Addendum No.: 4

Date Of Addendum: September 22, 2017

**Fire Alarm & Sprinkler Project  
Veterans' Home – 287 West Street  
Rocky Hill, CT 06067  
BI – C – 285 / FAI Number 09-016**

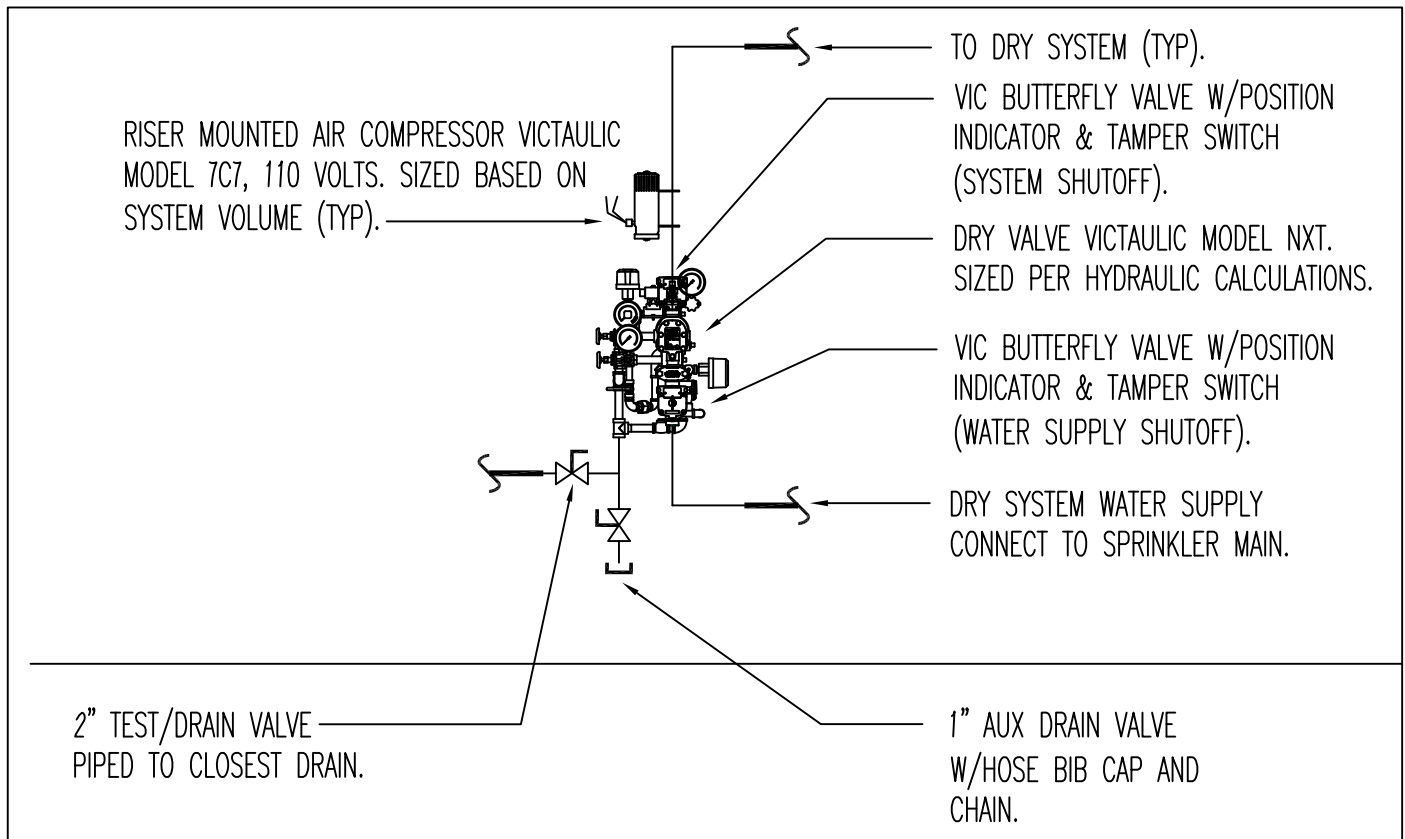
Question: Please forward main drain location for the DDV for the coolers as shown on FP-02.4.

Answer: Detail shows piping to closest floor drain.

## DRY VALVE PIPING DETAIL

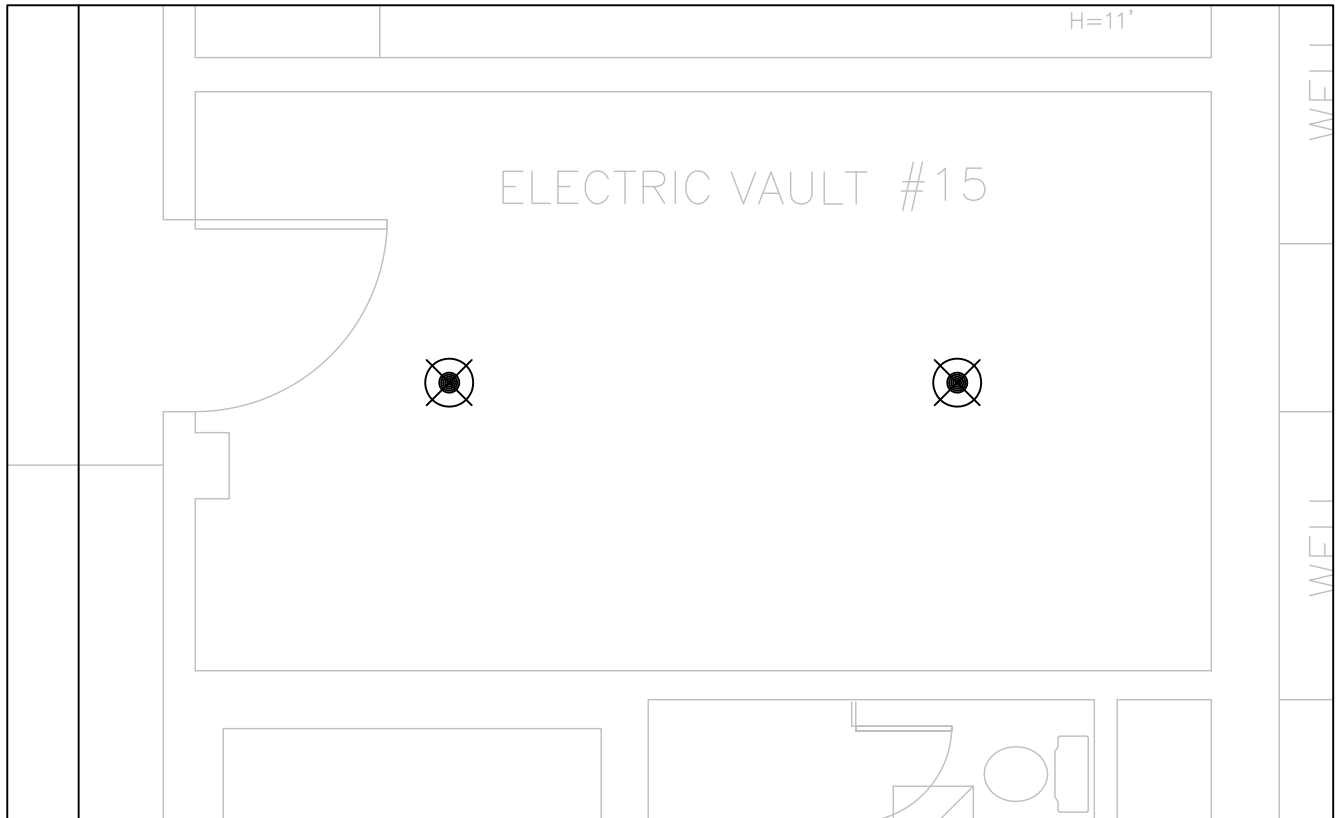
On Drawing FP-02.0, Detail C2 for the Dry Valve Piping Detail has been enlarged for readability. Refer to FSK-1.

# SPRINKLER RISER DETAIL

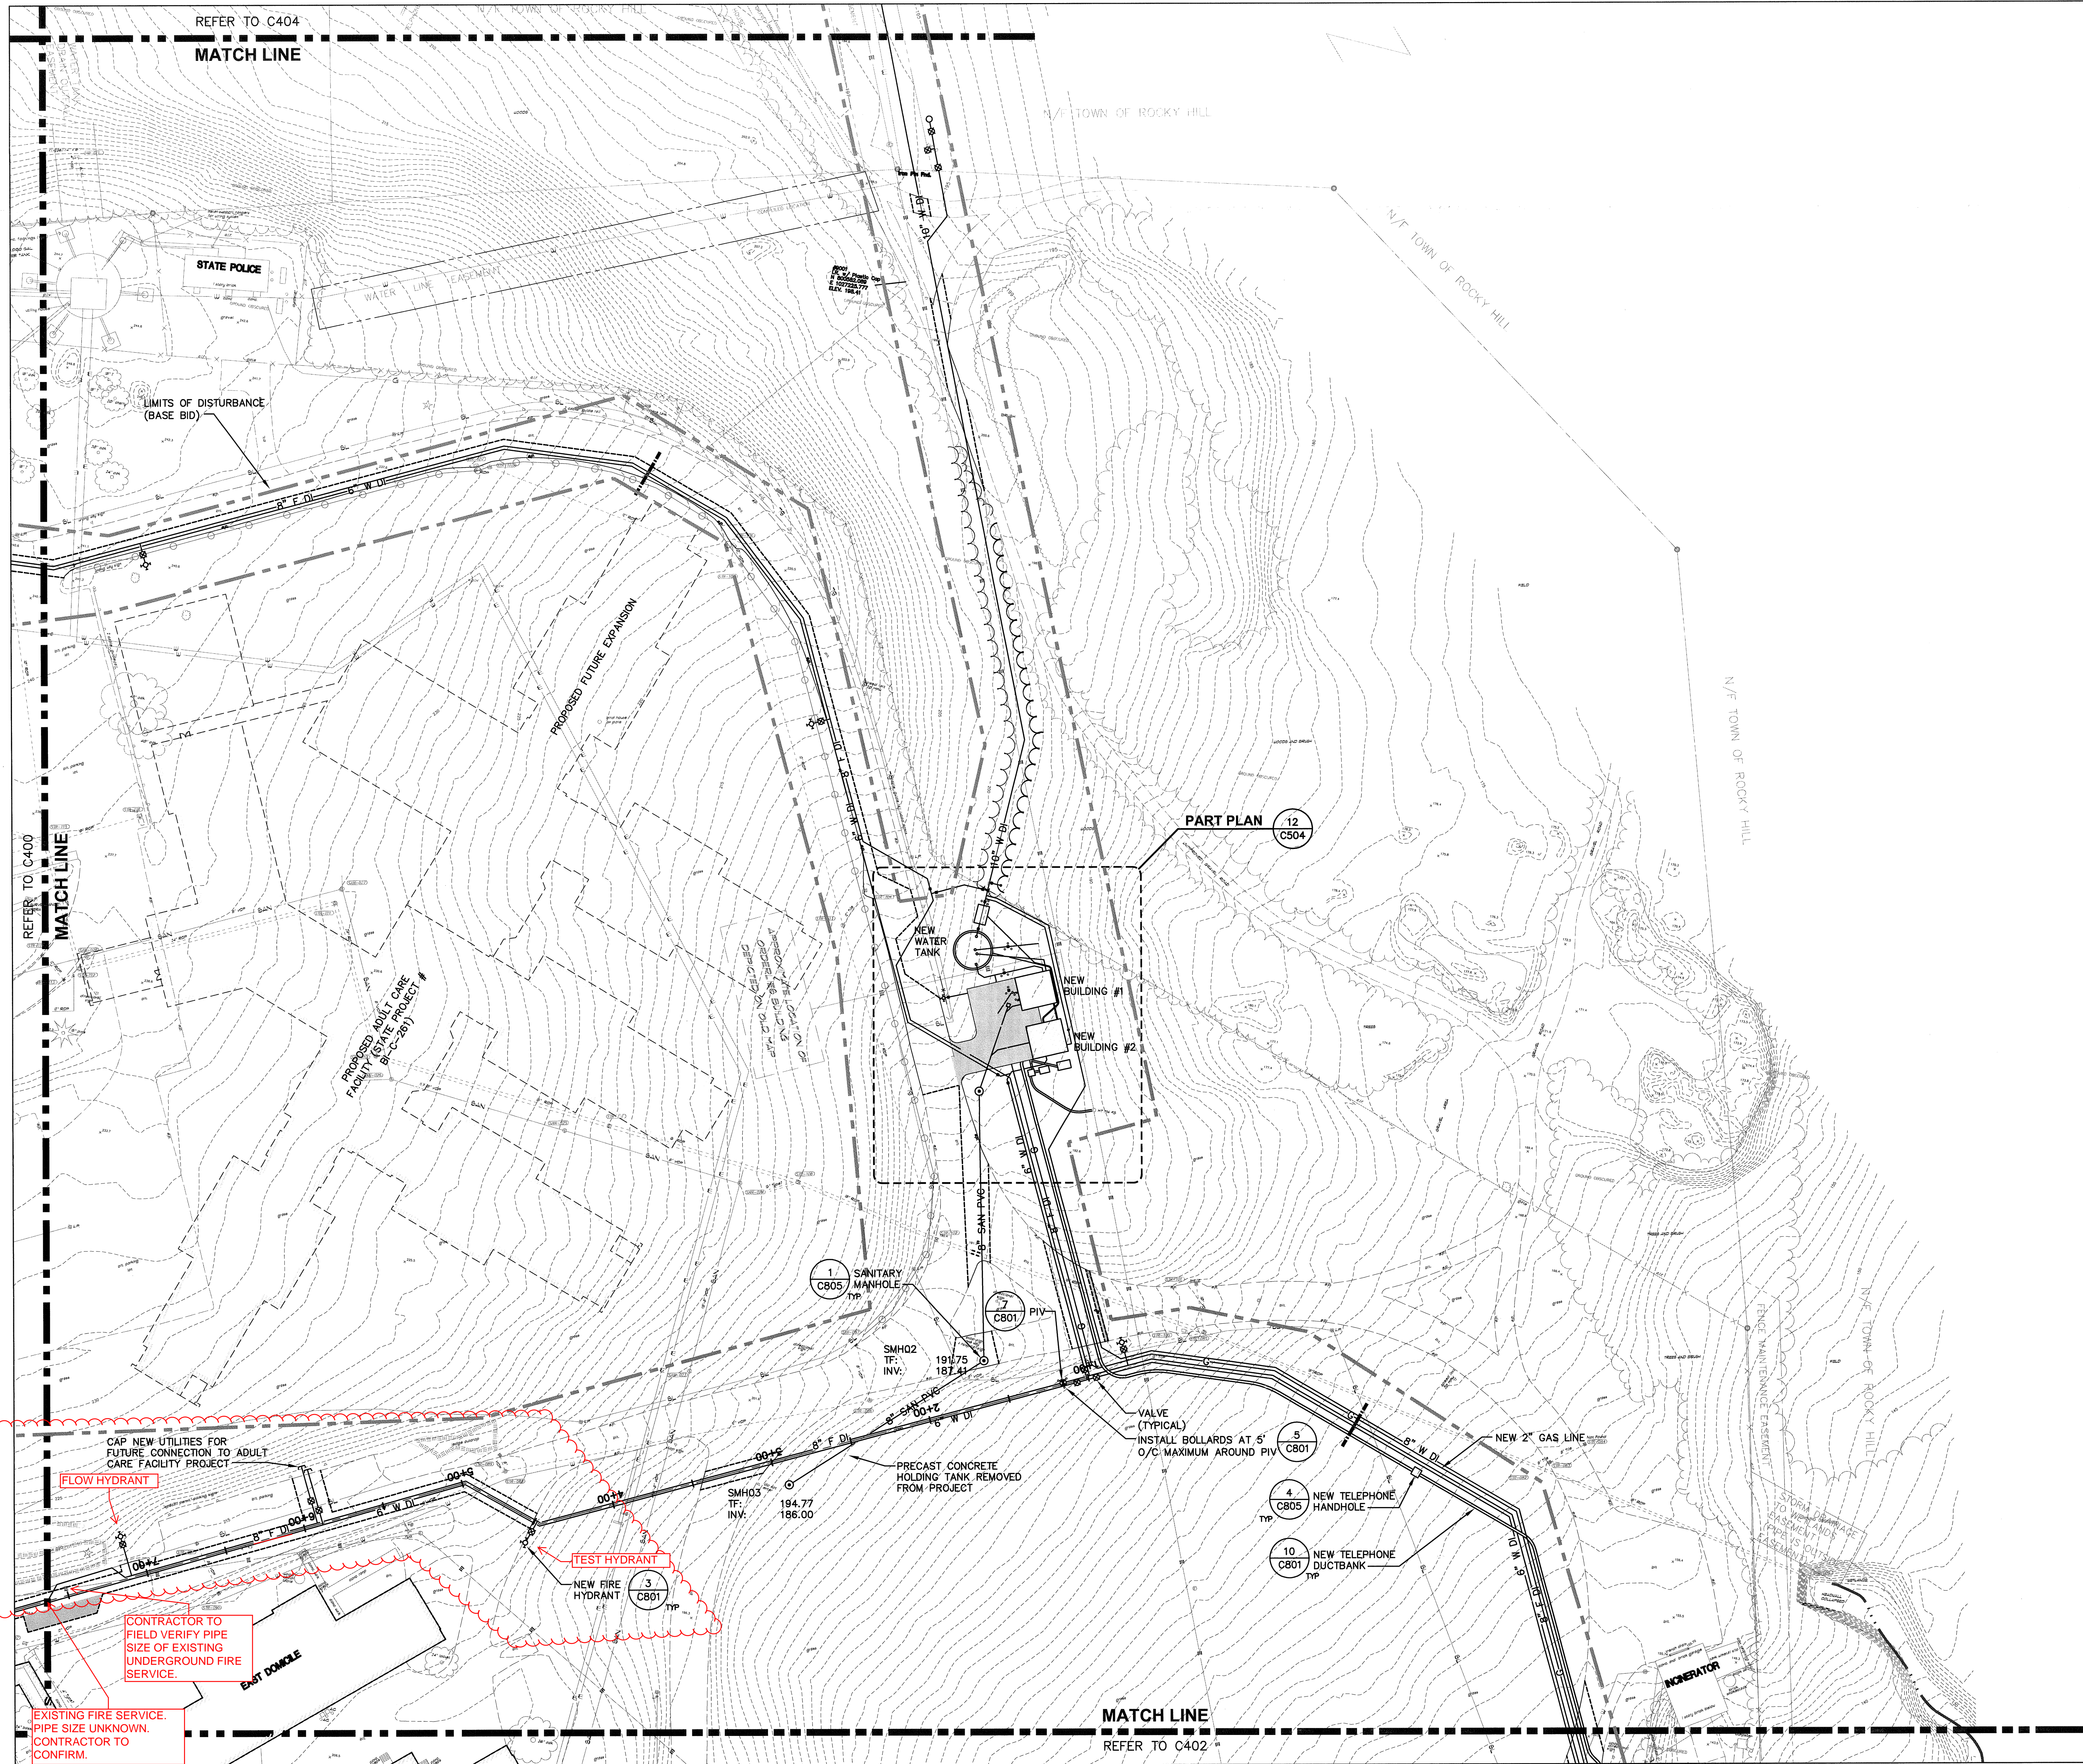
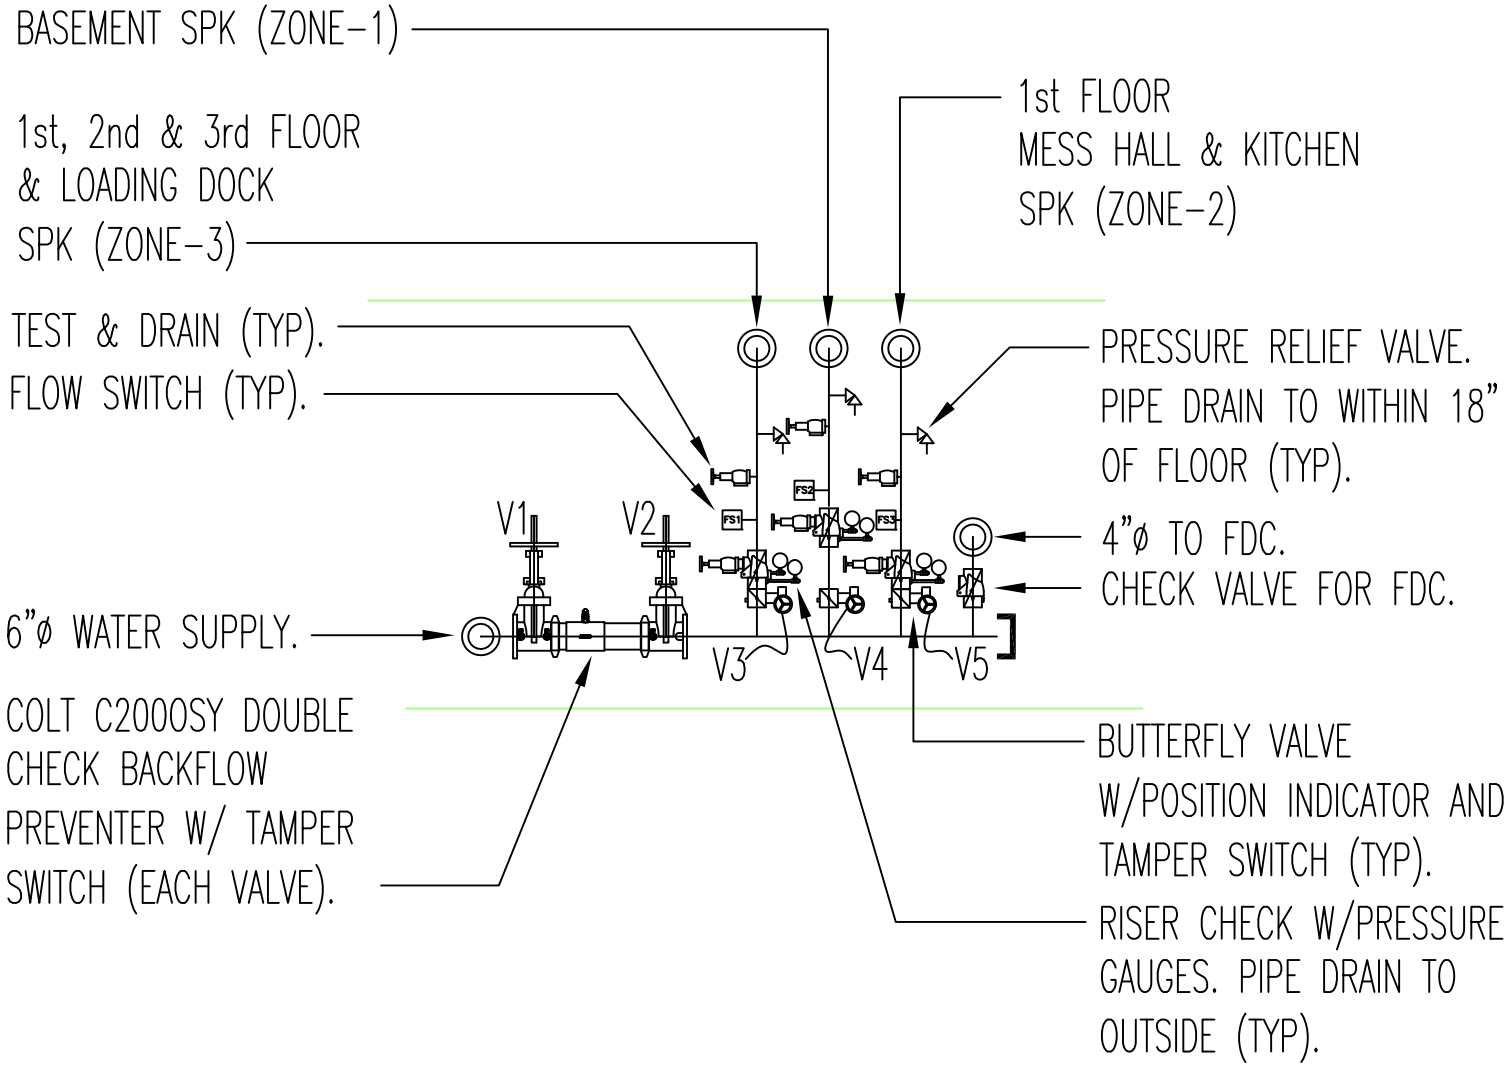
On Drawing FP-02.2, Detail C2 for the Sprinkler Riser Detail has been corrected so that the title of this detail is not merged with the notes in this section. Refer to FSK-3 & FSK-4.

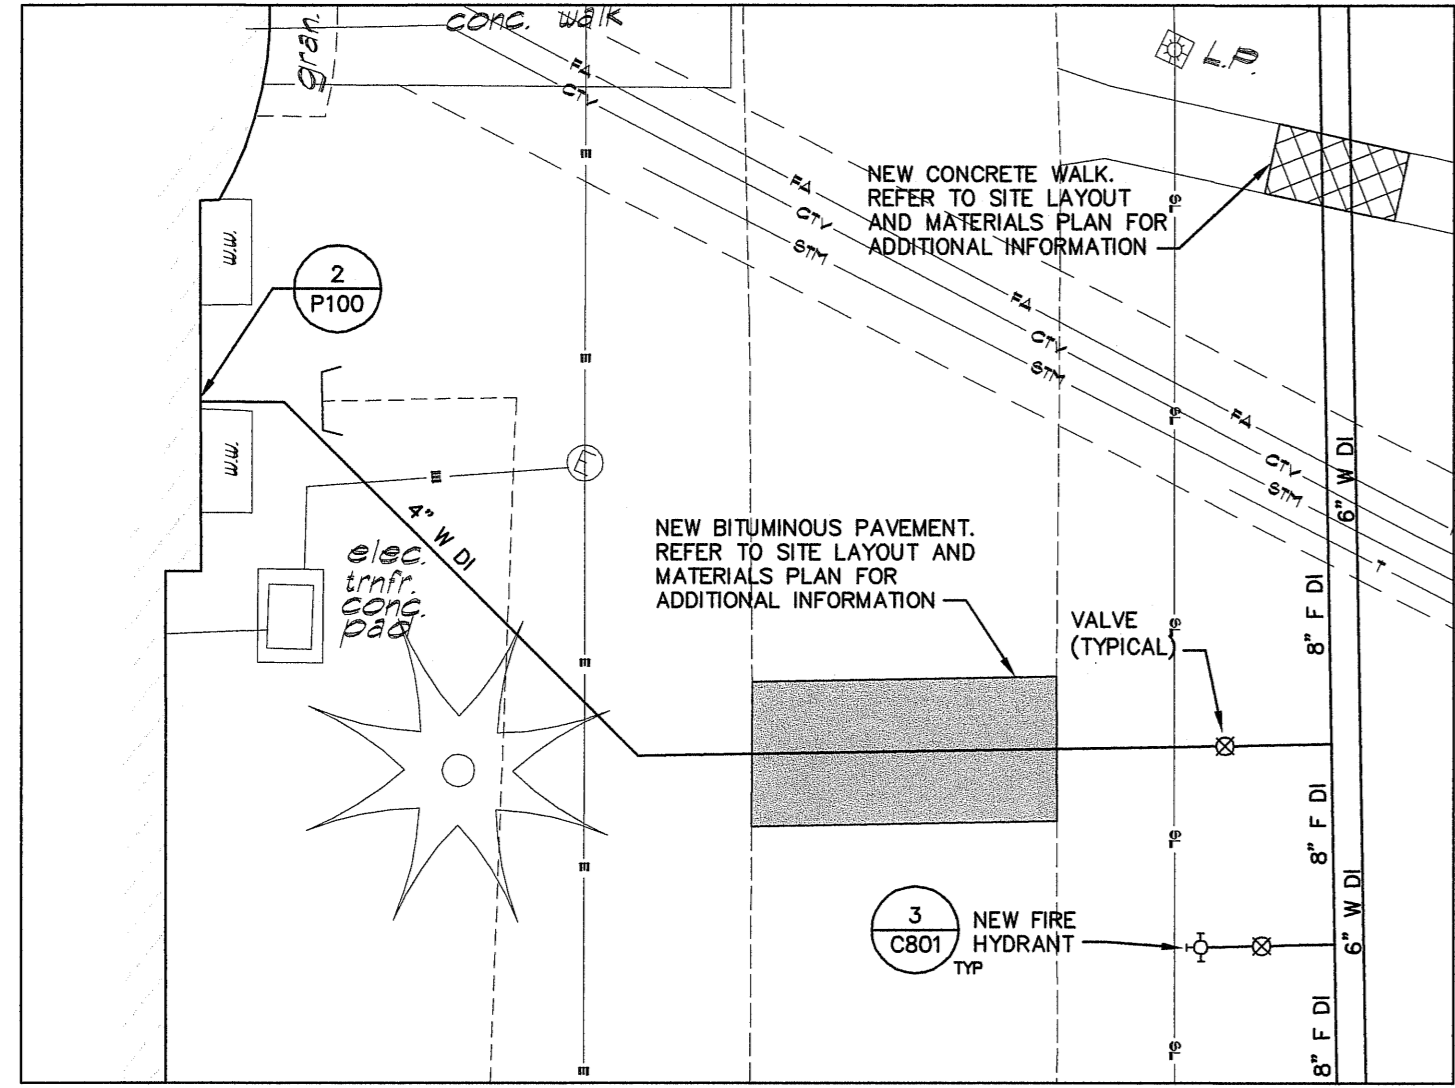
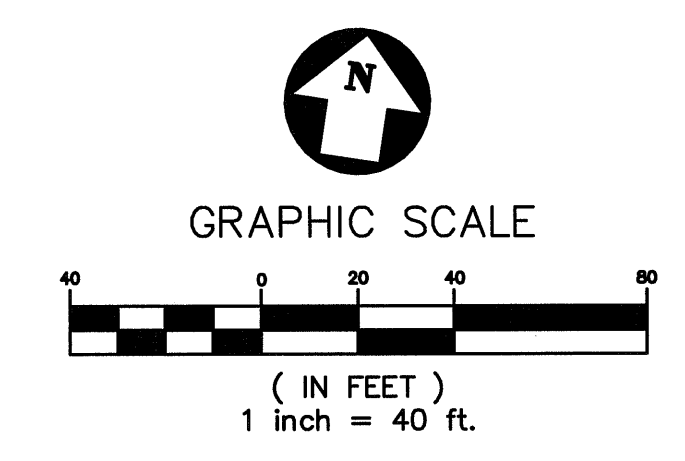
Existing Site water distribution drawings provided for reference (BI-C-265, C401, C501). 4" fire water service enters building #2. Contractor shall include exploratory digging to confirm pipe size in the field. For bidding purposes include new service with post indicating valve located at building run to "flow hydrant" location.
